Addendum No. 01

Date: April 09, 2026

Re: USOSM – Hopkin Oral Surgery
1377 E 3900 S
Salt Lake City, Utah 84124

Project No: 2025.79

FLOOR PLAN - PLUMBING - MED GAS
 DRAWN BY: HSF
 DATE: 03/12/26
 PROJECT NO: 2025.79
 SHEET NO:
P-4

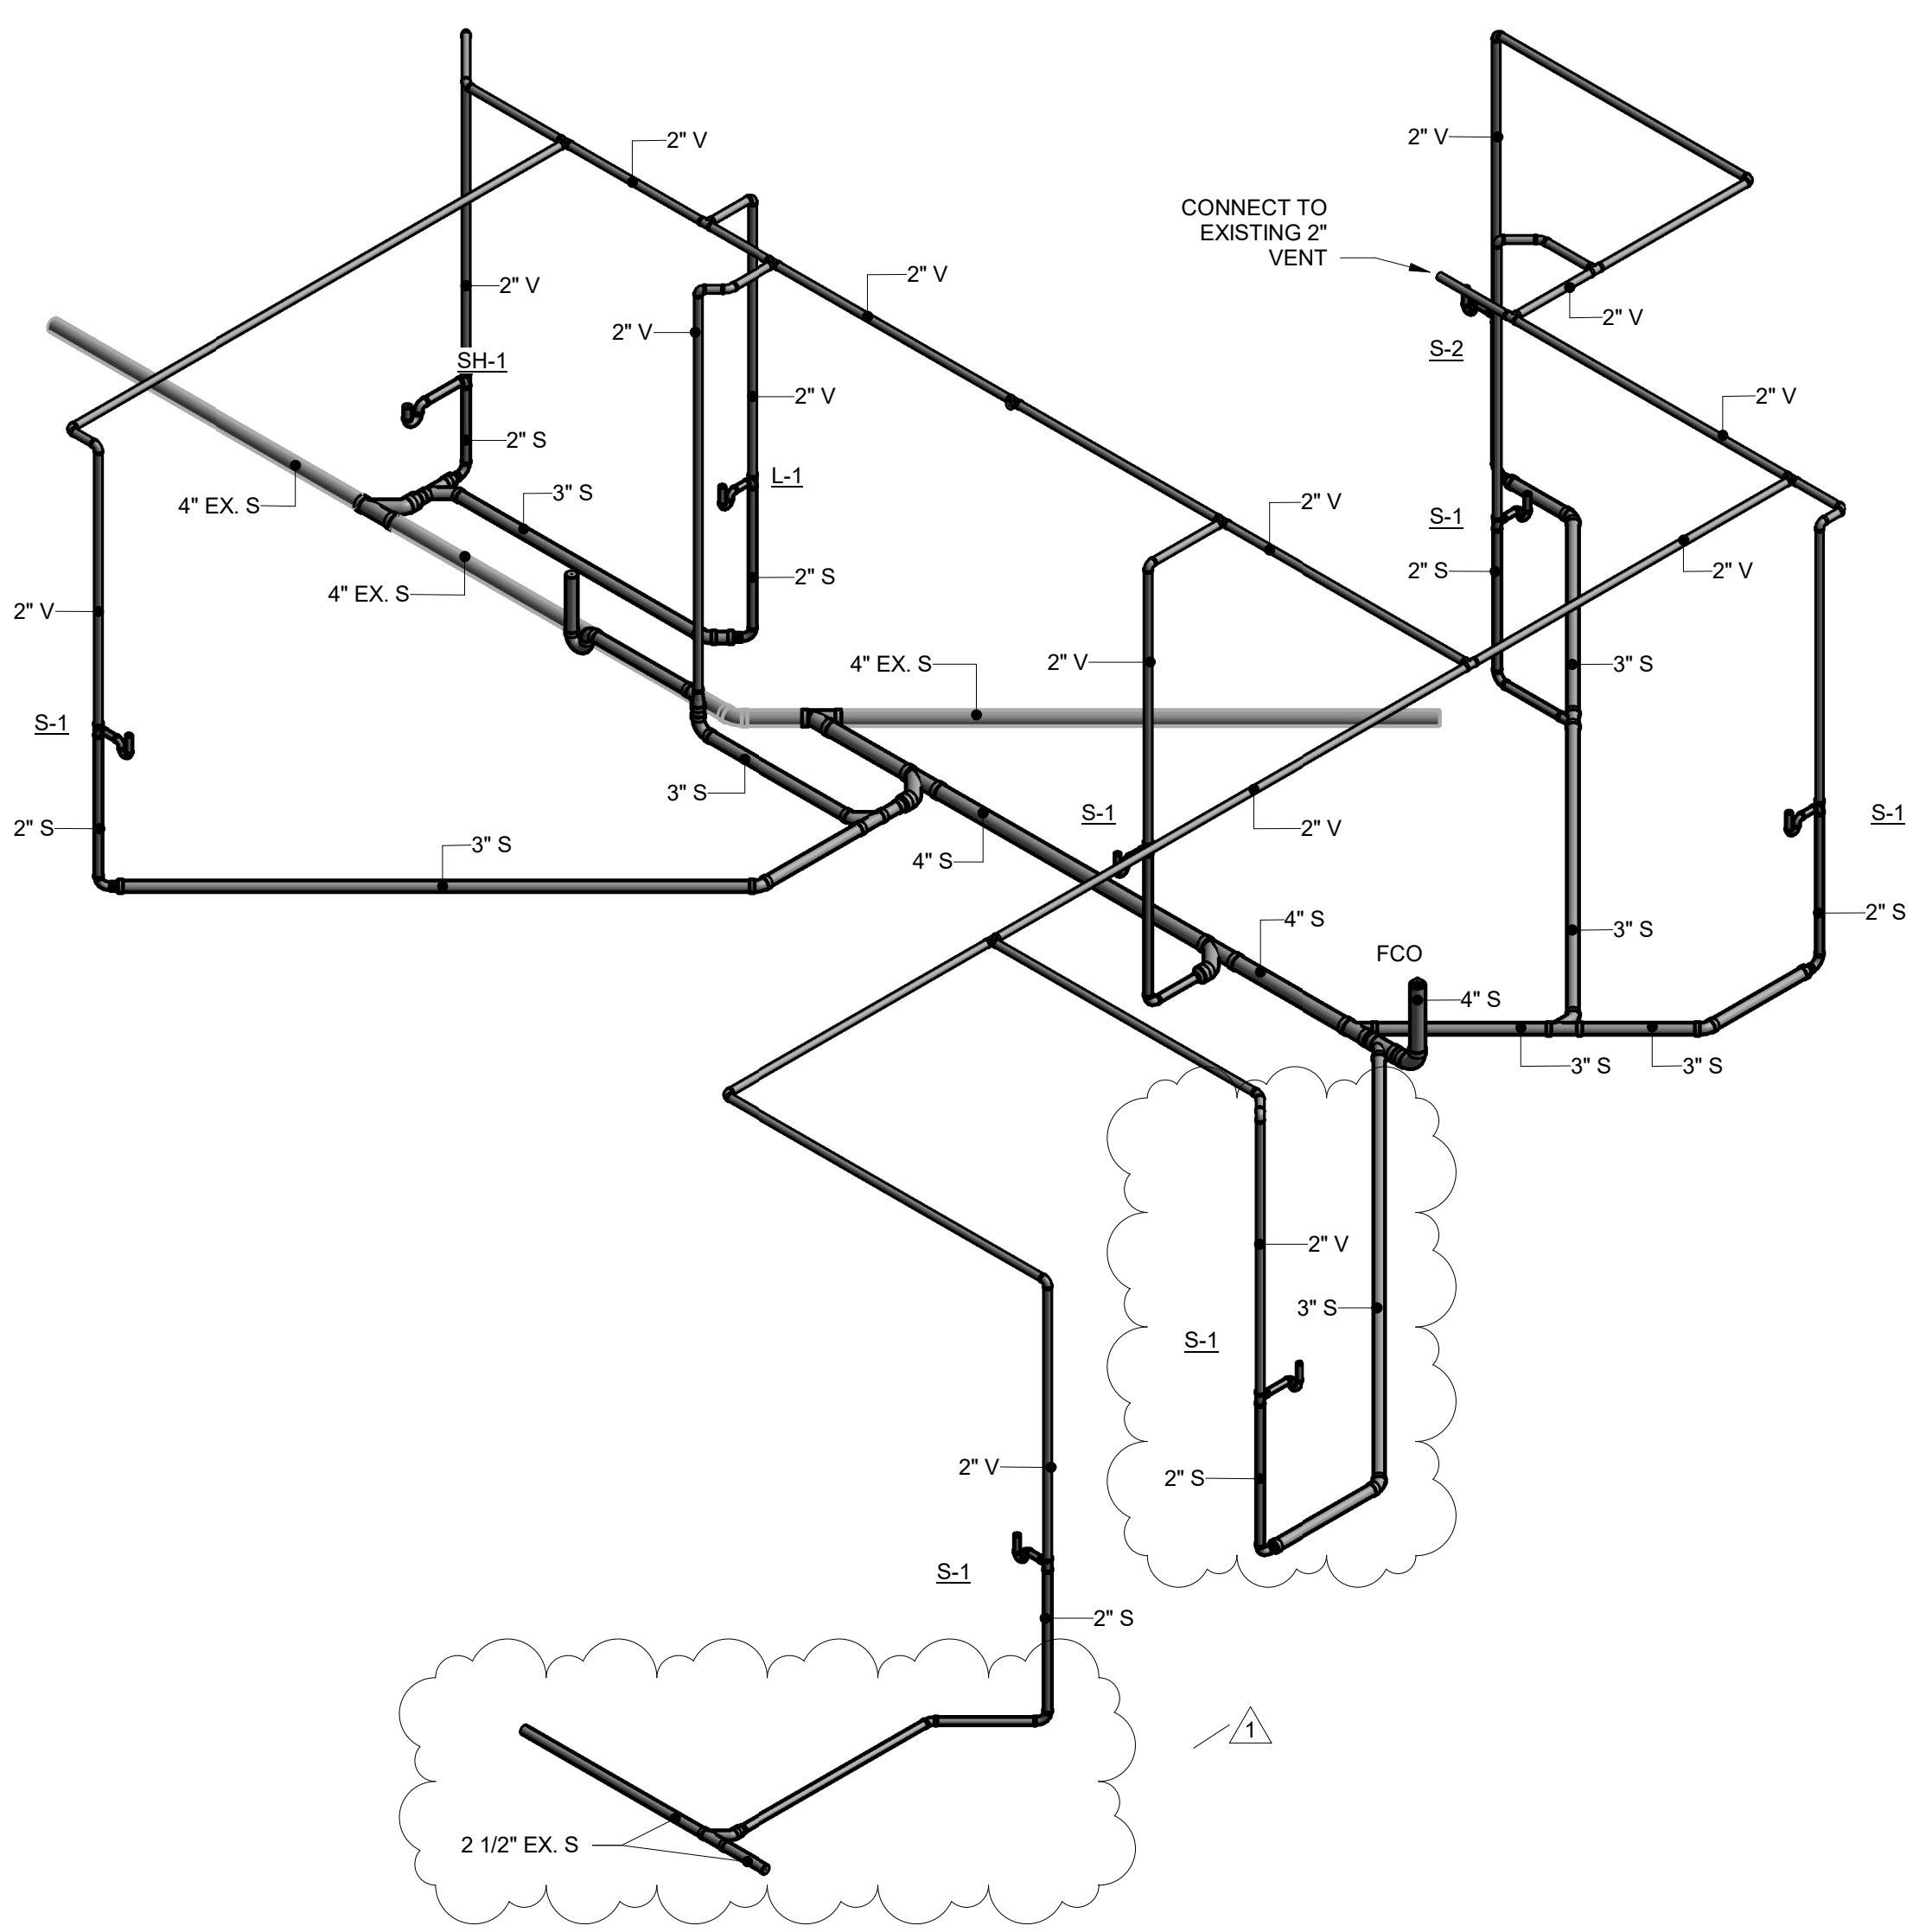
16. Revision:
Sheet P-4:
- A. Added maximum allowable medical gas volume to med gas room in keyed note #11 per plan review comment. (Permit Response)
 - B. Added additional description for medical gas pipping. (Engineer Clarification)

1 DW&V - ISOMETRIC
P-7 N.T.S.

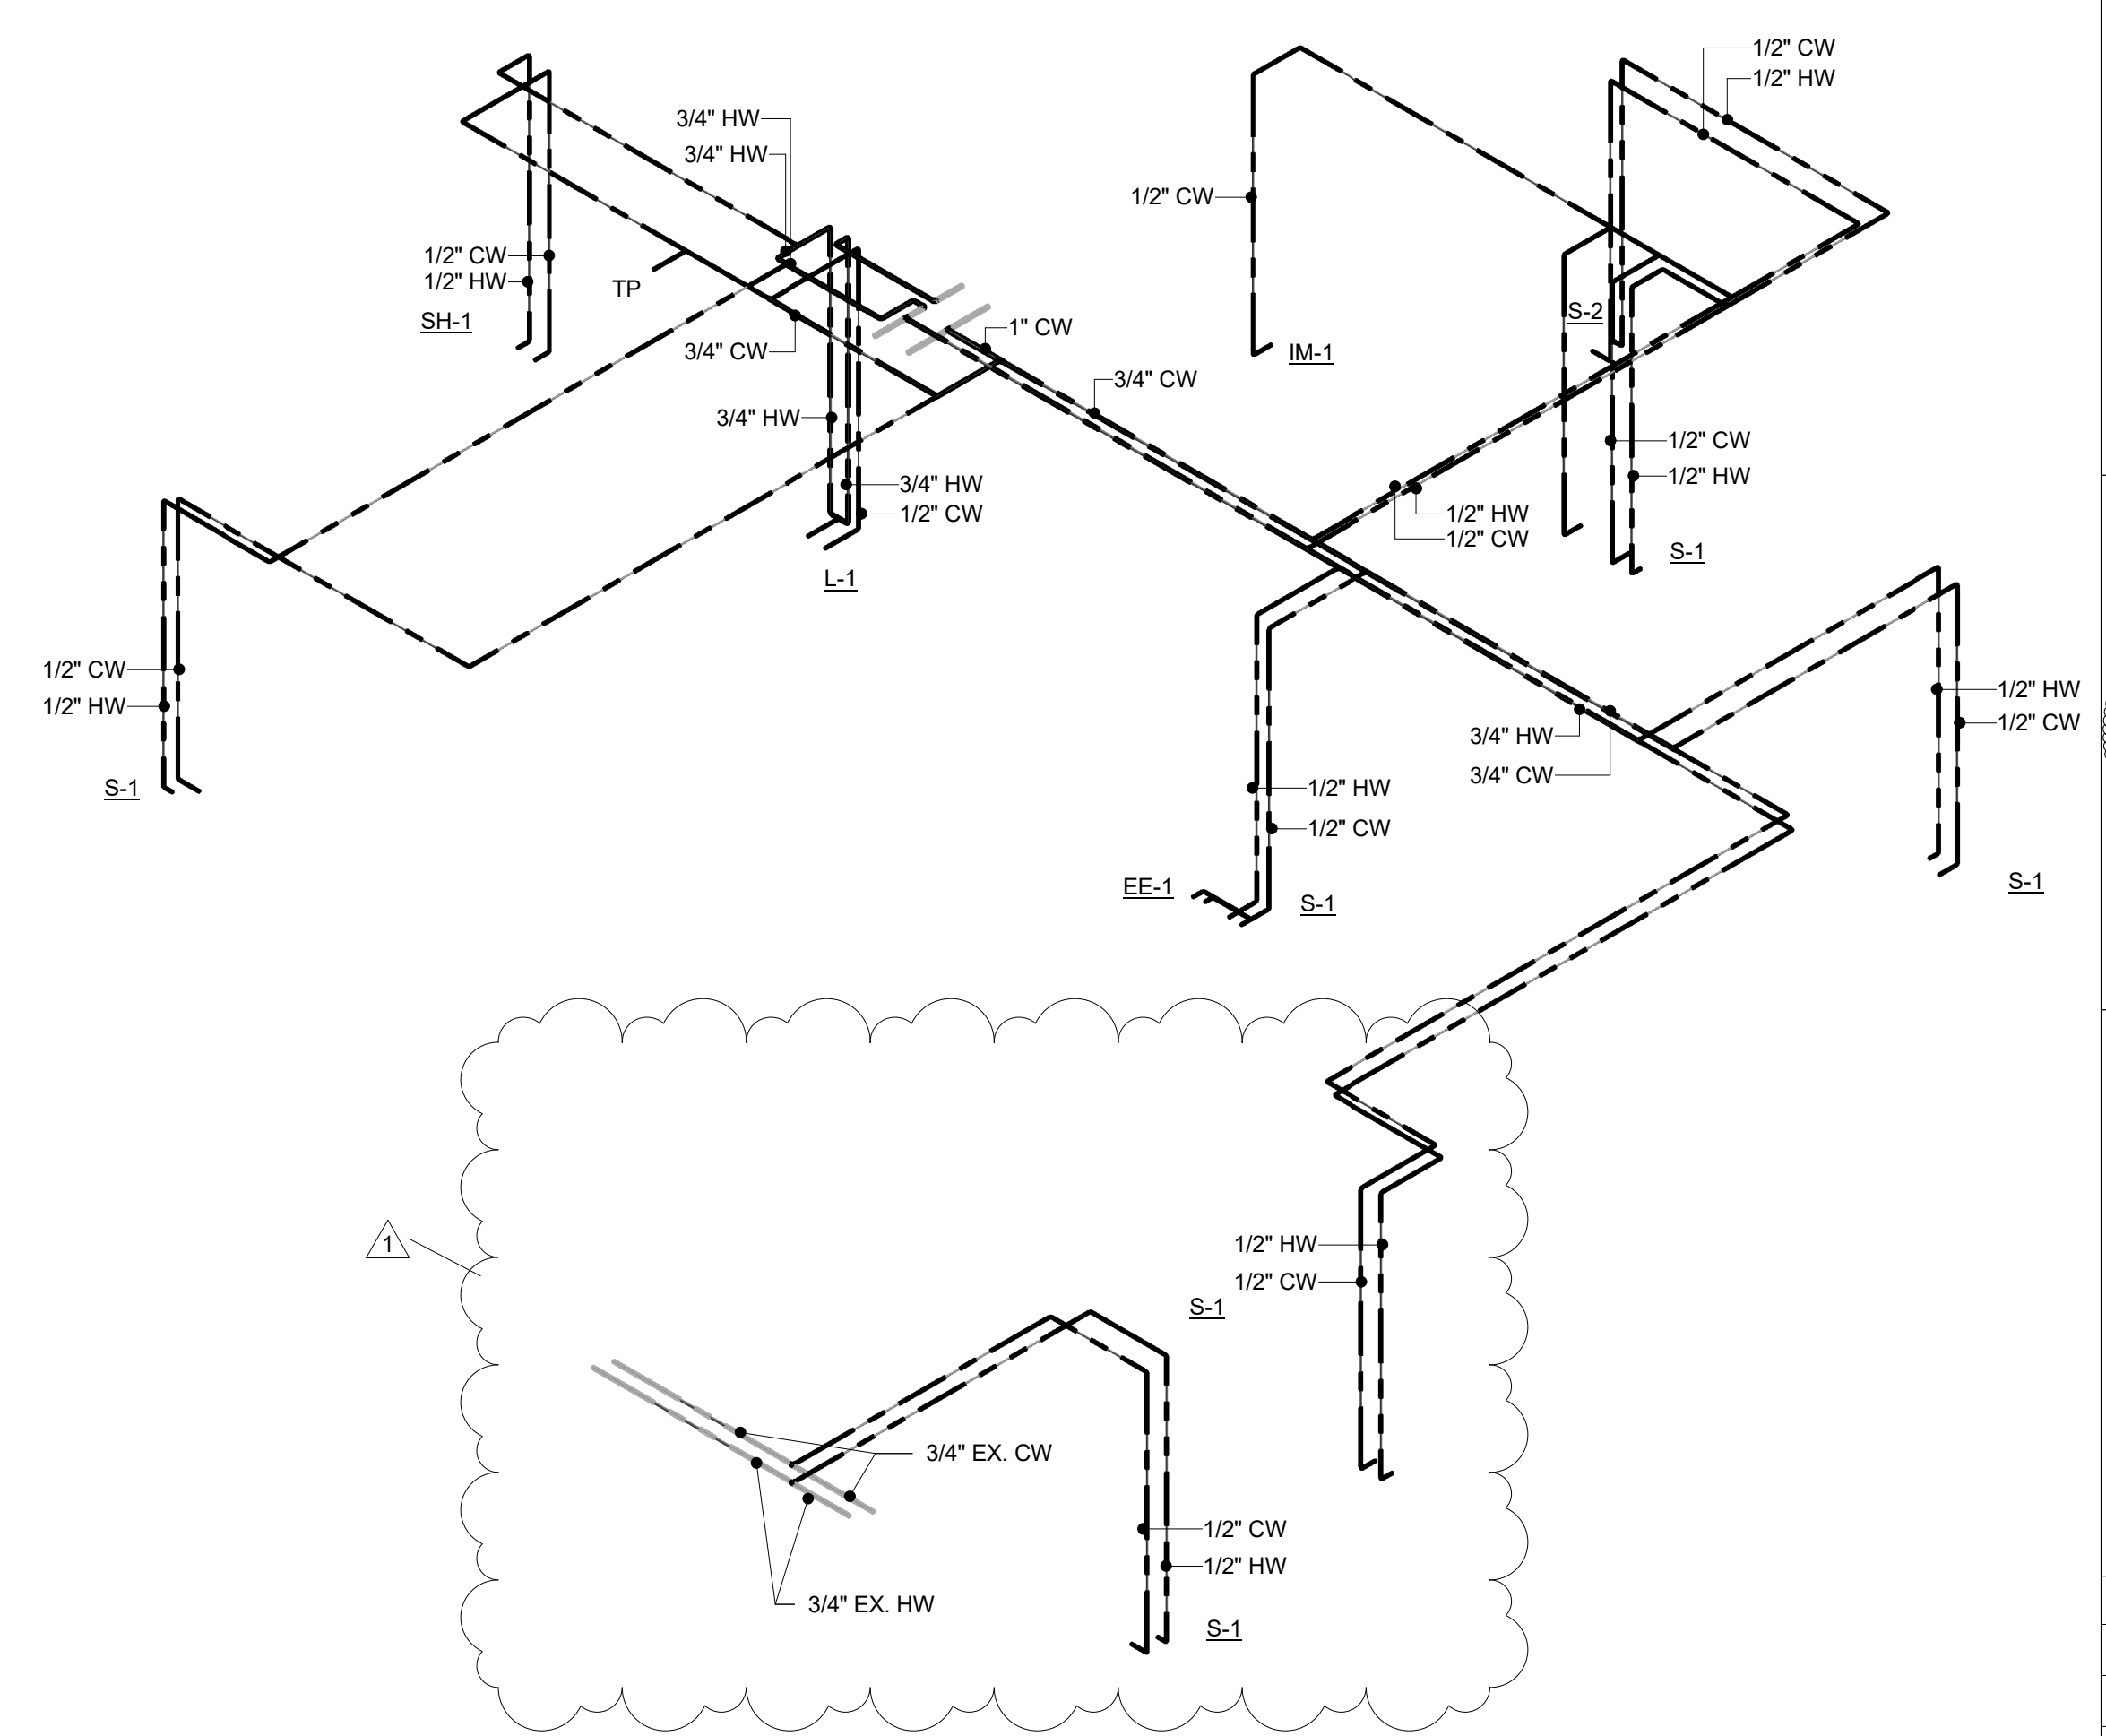
17. Revision:
Sheet P-5:
- A. Added keynotes to demo plan for additional fixture call outs. (Engineer Clarification)
18. Revision:
Sheet: P-7:
- A. Reflected the changes made to floor plans. (Engineer Clarification)
